CHAPTER 2

RISK ANALYSIS OF ROUTINE TRANSPORTATION

Figure 2-1. The upper sketch is an exploded view of a generic spent fuel cask. The lower sketch is a cross-section of the layers of the cask wall. (Sandia National Laboratories archive)

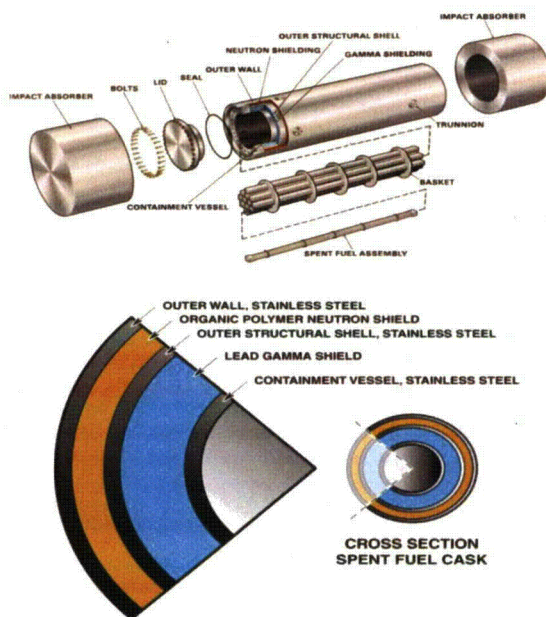
Comment [MF1]: Remind readers that the calculations are for 3 actual cask designs and Fig. 2-1 shows a typical cross section.

Figure 2-2. RADTRAN model of the vehicle in routine, incident-free transportation. The cask in this diagram is positioned horizontally, and the critical dimension is the cask length.

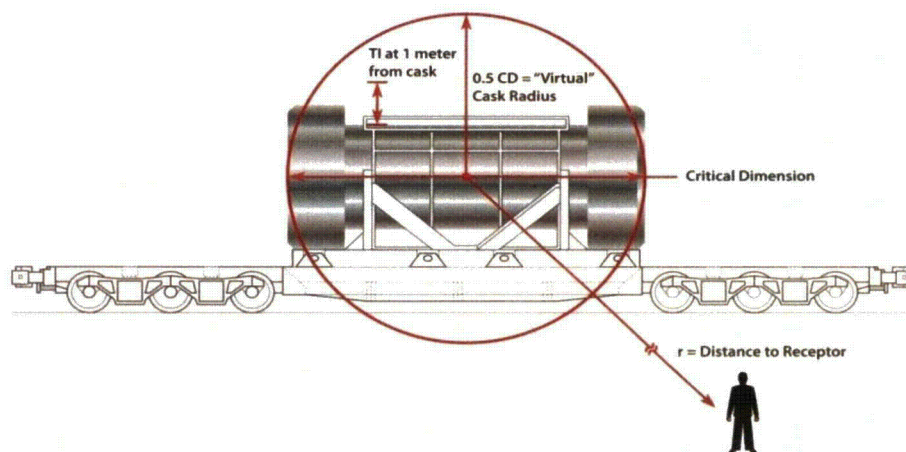
Comment [h15]: Is this an important assumption?

Figure 2-6. Highway and rail routes from Kewaunee Nuclear Plant.

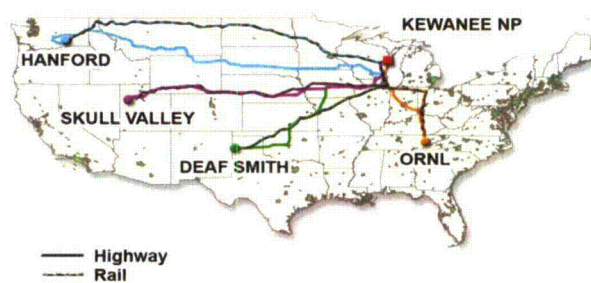
Comment [MF25]: This figure has been squished down so it is not the same shape as the other route figures in this chapter.

Figure 2-11. Collective doses from background and from one of the truck shipments of spent nuclear fuel (person-Sv)

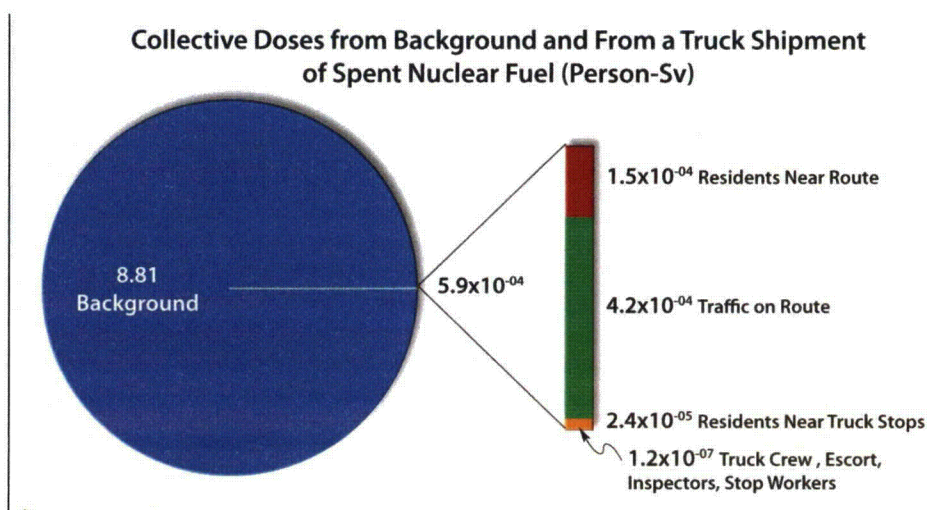
Comment [h57]: EDITORIAL: In what ways are the doses overestimates? A brief description of the major conservatisms that lead to these overestimates would be very useful.

Comment [MF58]: This is not clear since many non-conservatism are included as assumptions.

Comment [MF59]: Were any of these reported in the chapter? The conclusions should not introduce new material.
